**SUSQUEHANNA STEAM ELECTRIC STATION
EMERGENCY PLAN REVISION 60
PLA- 7566**

**Docket Nos. 50-387
and 50-388**

The purpose of this letter is to transmit Revision 60 to the Susquehanna Steam Electric Station (SSES) Emergency Plan. Revision 60 to the Emergency Plan contains Emergency Action Level (EAL) changes associated with incorporation of NEI 99-01, Revision 6, "Development of Emergency Action Levels for Non-Passive Reactors," which were approved for use by the NRC in a Safety Evaluation Report (SER) dated March 28, 2016. Revision 60 also contains changes that do not require NRC approval. In accordance with the requirements of 10 CFR 50.54(q), Revision 60 to the Emergency Plan does not result in a reduction in effectiveness of the plan and the Plan, as changed, continues to satisfy the applicable requirements of 10 CFR 50.47(b) and Appendix E to 10 CFR 50. Revision 60 was effective December 16, 2016.

List of Changes Contained in
Revision 60 to SSES Emergency Plan

TSC ORGANIZATION

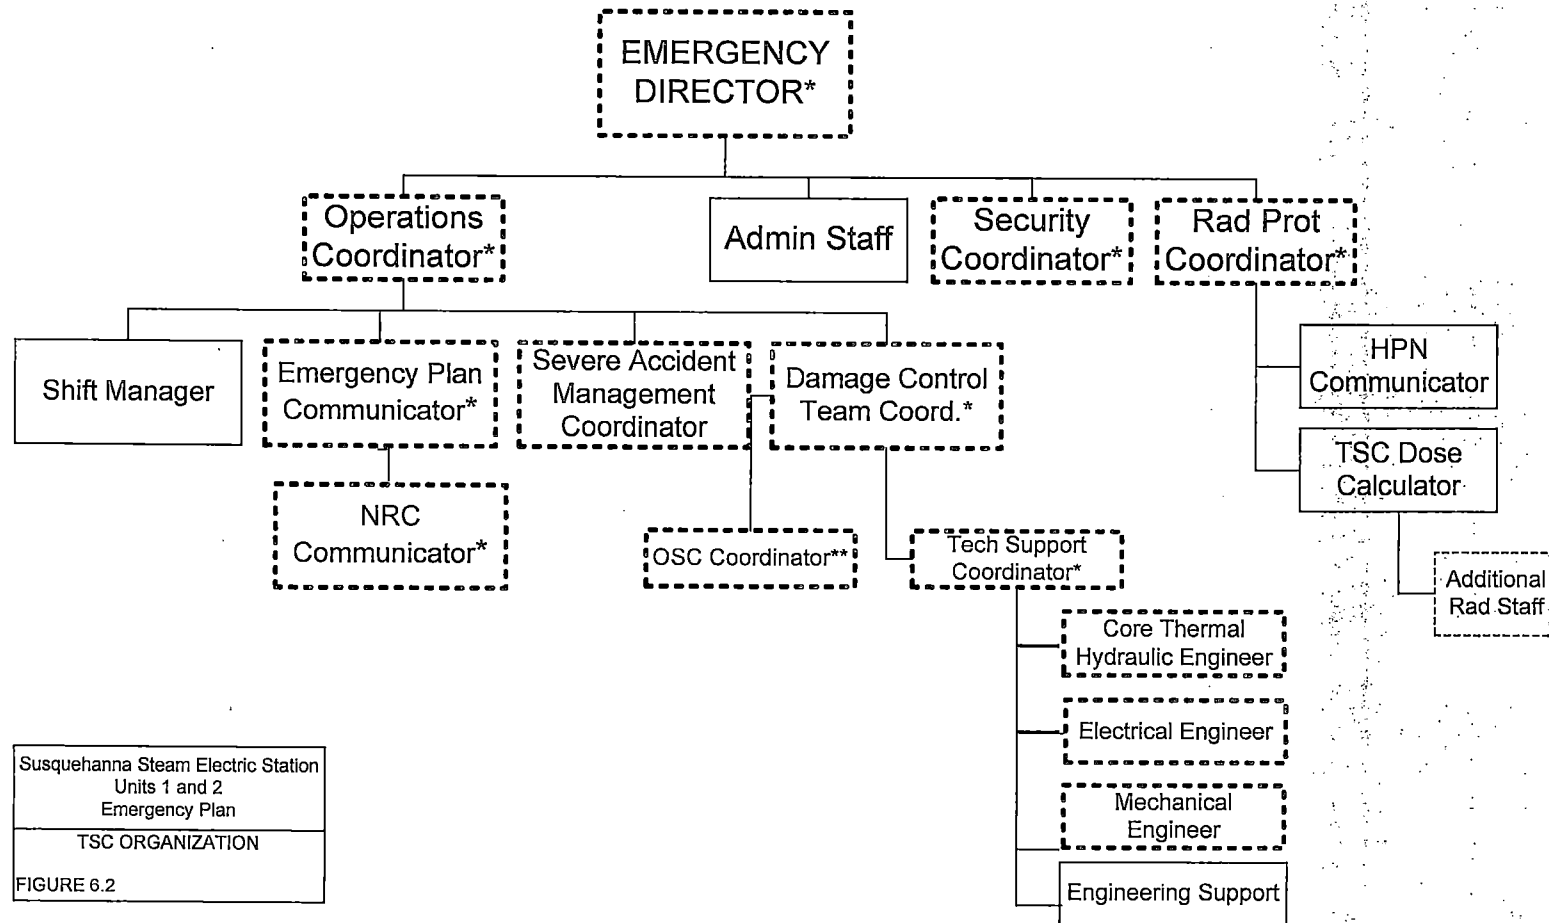
28. Divided step 6.2.3 TSC Communicator into steps 6.2.3 TSC NRC Communicator and 6.2.4 TSC Emergency Plan Communicator to match Table 6.1 and Figure 6.3. (CR-2016-21635). **This was an oversight when Table 6.1 and figure 6.3 were changed from a single position (TSC Communicator) to two positions (TSC Emergency Plan Communicator and TSC NRC Communicator) in Revision 58 of the Emergency Plan. The justification for both positions is provided in E2014-06-19-01. Along with changes 30 and 31, the text, table 6.1 and figures 6.2 and 6.4 are now in agreement. No additional evaluation required.**

FIGURE 6.3

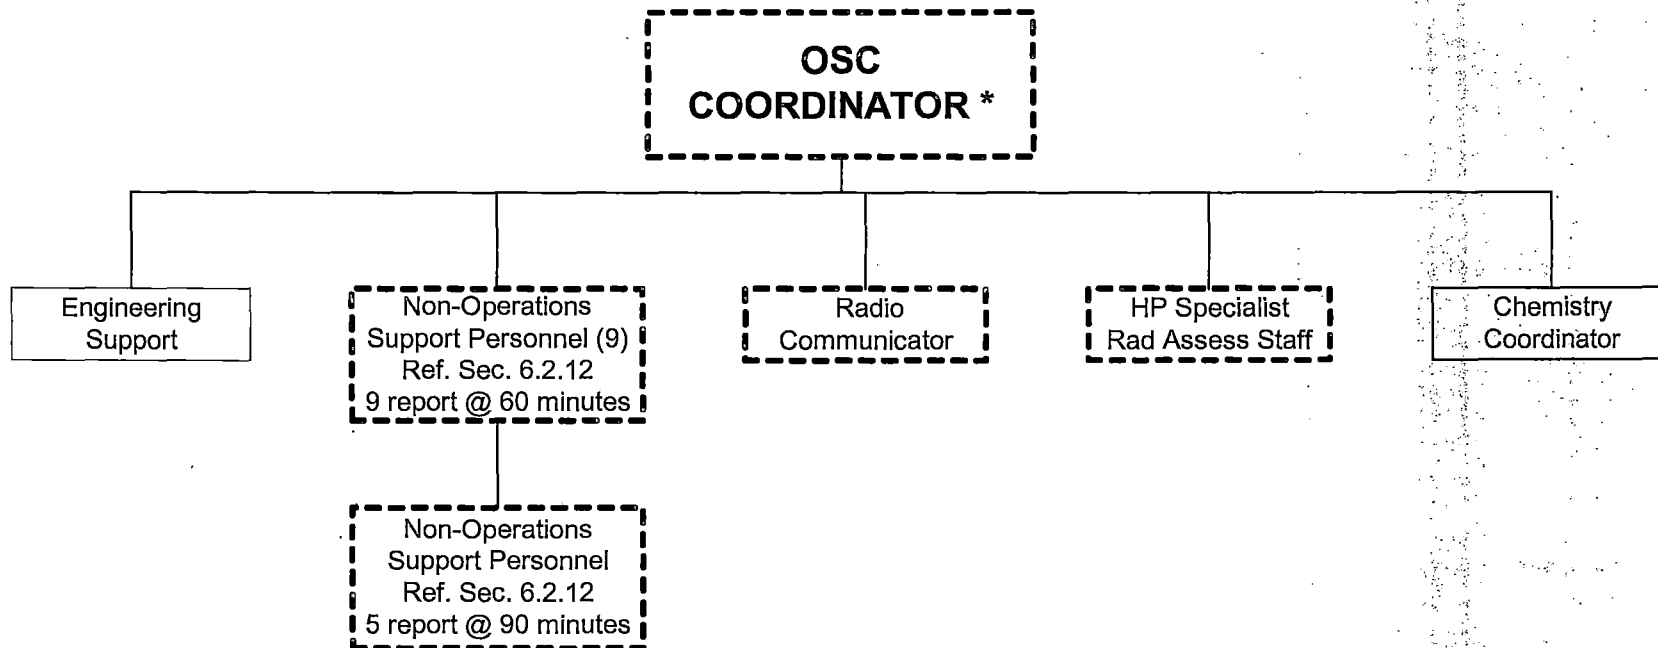
27. Existing Table C was replaced with new EAL Table C.
28. Divided step 6.2.3 TSC Communicator into steps 6.2.3 TSC NRC Communicator and 6.2.4 TSC Emergency Plan Communicator to match Table 6.1 and Figure 6.3. (CR-2016-21635).

Susquehanna Steam Electric Station Units 1 and 2 Emergency Plan
EOF ORGANIZATION
FIGURE 6.4

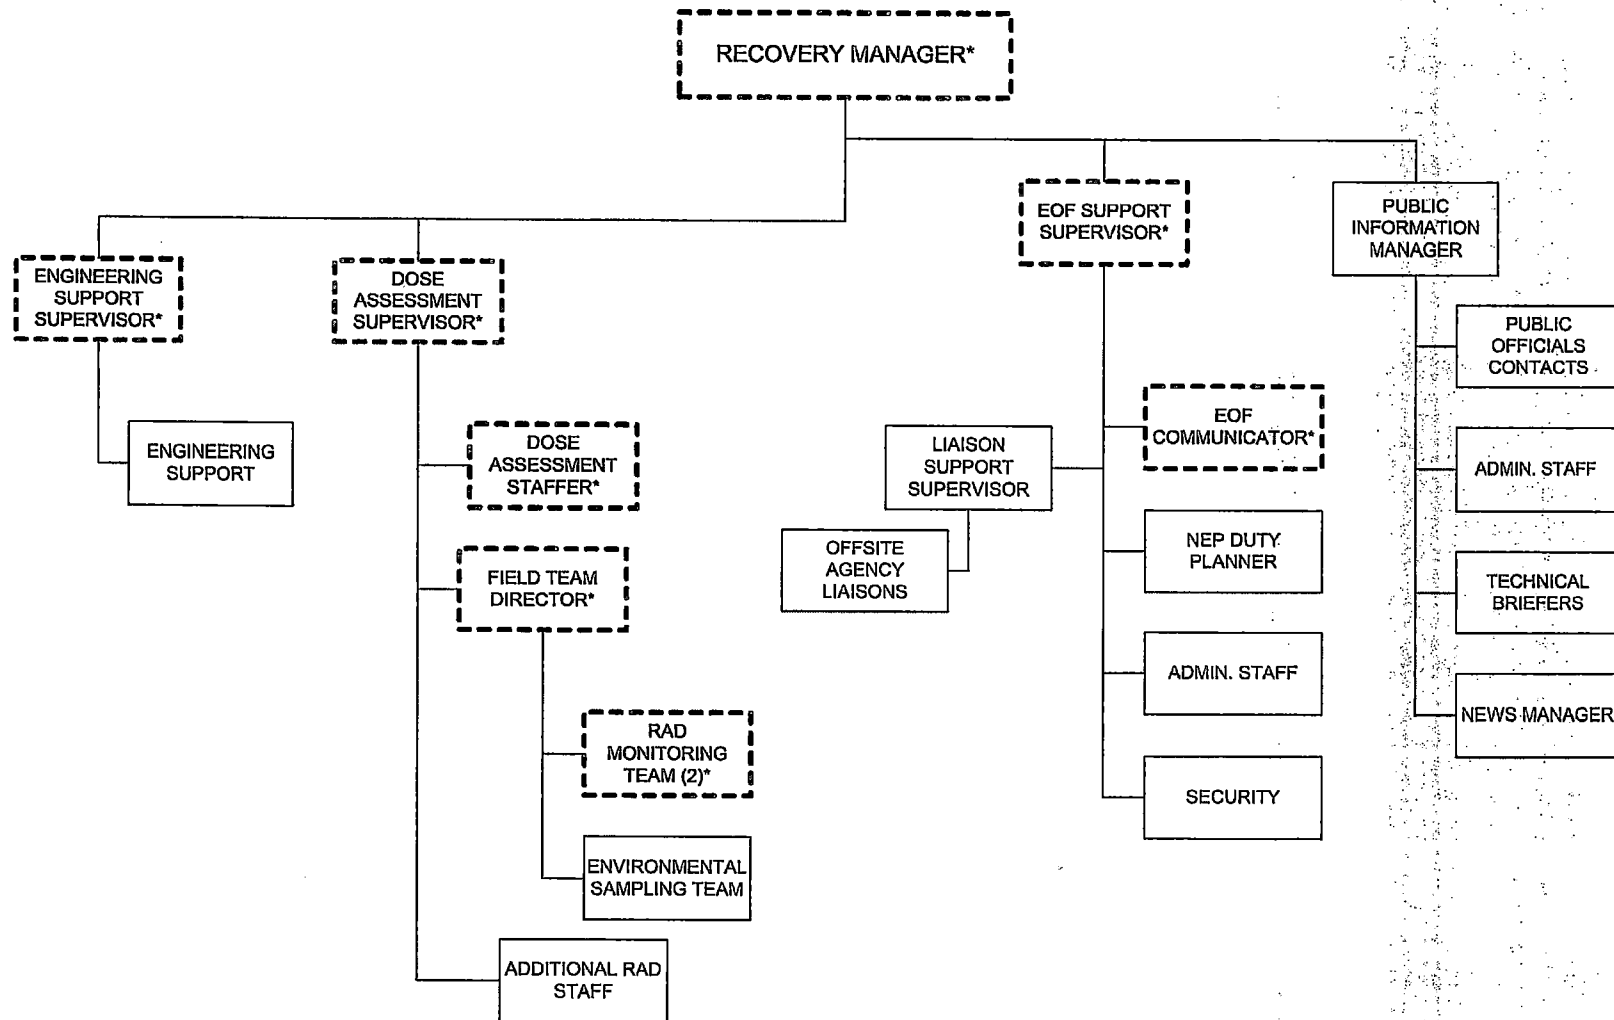
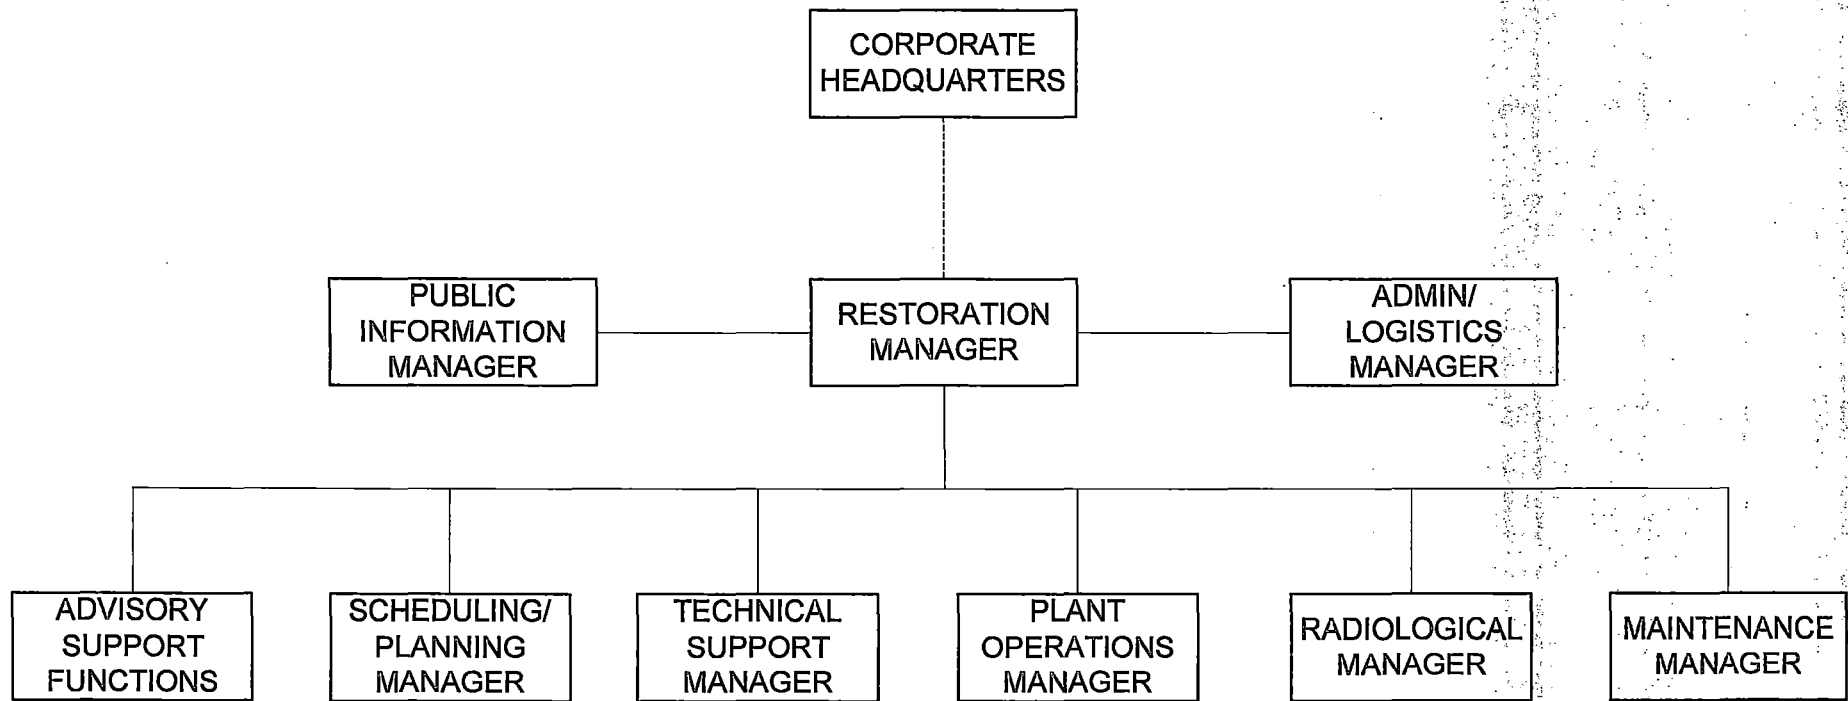
30. On Table 6.1 removed the superscript * from the 60 minute positions of Emergency Plan Communicator and NRC Communicator. The superscripts were added in error in Emergency Plan Revisions 58 and 59. The superscript * refers to a note associated with on-shift personnel.

31. On Table 6.1 removed the superscript * from the 90 minute position of Emergency Plan Communicator. The superscripts were added in error in Emergency Plan Revision 59. The superscript * refers to a note associated with on-shift personnel. Also moved the designator "1" from the NRC Communicator line to the EOF Support Supervisor line. This corrects a typographical error in Emergency Plan Revision 59.

30. On Table 6.1 removed the superscript * from the 60 minute positions of Emergency Plan Communicator and NRC Communicator. The superscripts were added in error in Emergency Plan Revisions 58 and 59. The superscript * refers to a note associated with on-shift personnel. **Administrative change only. Along with changes 28 and 31, the text, table 6.1 and figures 6.2 and 6.4 are now in agreement. No evaluation required.**

31. On Table 6.1 removed the superscript * from the 90 minute position of Emergency Plan Communicator. The superscripts were added in error in Emergency Plan Revision 59. The superscript * refers to a note associated with on-shift personnel. Also moved the designator "1" from the NRC Communicator line to the EOF Support Supervisor line. This corrects a typographical error in Emergency Plan Revision 59. **Along with changes 28 and 30, the text, table 6.1 and figures 6.2 and 6.4 are now in agreement. Administrative change only. No evaluation required.**
